Determination 2012/020

Adequacy of documentation in respect of remedial work proposed to window heads to a house at 723 Glenmark Drive, Waipara

Applicant: G Herbert (the owner)
The authority: Hurunui District Council

Figure 1: Interpretation of proposed head detail as submitted by applicant

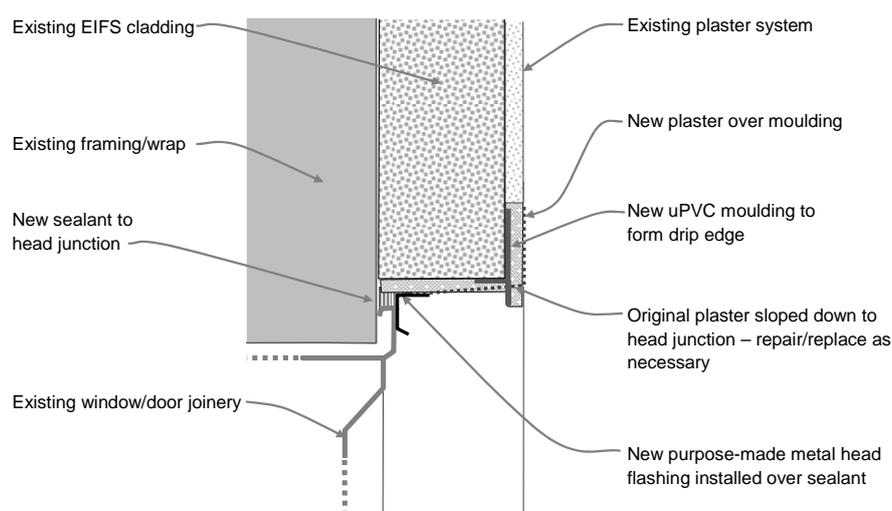
- it accepts the proposal as shown in figure 1 (noting that this had never been presented to the authority) subject to information around the plastering repair technique where the new head flashing is being installed.

- 5.2 The applicant's sketch of the proposal is unclear and Figure 1 in paragraph 2.3.1 is my interpretation of what the applicant appears to propose. Providing Figure 1 accurately reflects the proposal, I make the following observations in regard to its compliance with Clauses E2 and B2:

- The proposal addresses the lack of drip edges and head flashings in the exposed windows and doors by:
 - removing the slope of the plaster towards the vulnerable head junction

- providing a drip edge to prevent water tracking over the head reveal
 - adding protection to the head junction with a face-fixed metal head flashing.

- Providing the above work is satisfactorily completed, additional shelter is afforded the window heads by the EIFS reveal.
 - Although there is no visible evidence of existing head flashings, some original underlying protection of the head junction is likely to have been provided as part of the original proprietary EIFS system.

- 5.3 The sketch submitted to the authority in support of the proposal is not sufficient to clearly demonstrate compliance with the Building Code, and I have had to infer my view of its compliance as above. The details of the proposal therefore need to be clarified to the satisfaction of the authority (see also paragraph 4.5, fourth bullet point). In addition any proposal needs to show how the proposed remedial head flashing abuts the existing jamb flashing and/or reveal detail.

- 6.1 In accordance with section 188 of the Building Act 2004, I hereby determine that based on the documentation provided to the authority, there is insufficient information to establish on reasonable grounds that the proposed alteration to the exposed window heads will comply with Building Code Clauses B2 Durability and E2 External Moisture.
